REMARKS

AMENDMENTS TO THE DRAWINGS

FIG. 1
(PRIOR ART) ← KINDLY ADD

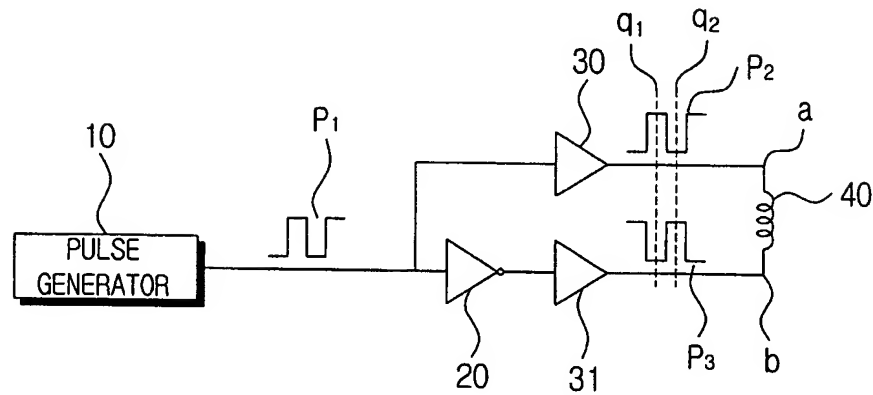
In the outstanding Office action, the Examiner objected to the drawing figures. In particular, the Examiner objected to FIG. 1 for failing to include the legend "PRIOR ART" and to FIG. 2 for being unclear.

The Examiner further indicated that the interconnection between FIGS. 2, 3 and 4 is unclear. Applicants respectfully submit that the instant amendment to FIG. 2 clarifies the relationship between FIGS. 2, 3 and 4.

By the instant amendment, addition of a legend "PRIOR ART" has been proposed in FIG. 1 and addition of a previously omitted element, viz., AND gate 160, has been proposed in FIG. 2. No new matter has been added to the instant amendment to FIG. 2 as the relationship between the pulse controller 110, the pulse generator 120, and the AND gate 160 is illustrated in FIG. 4 as originally filed.

The attached sheets of drawings include proposed changes to FIGS. 1 and 2. The attached drawing sheet of FIGS. 1 and 2 replaces the original drawing sheet of FIGS. 1 and 2. In FIG. 1, addition of a legend "PRIOR ART" has been proposed. In FIG. 2, addition of a previously omitted element, viz., AND gate 160, and deletion of some aspects have been proposed. No new matter has been added to the instant amendment to FIG. 2 as the relationship between the pulse controller 110, the pulse generator 120, and the AND gate 160 is illustrated in FIG. 4 as originally filed.
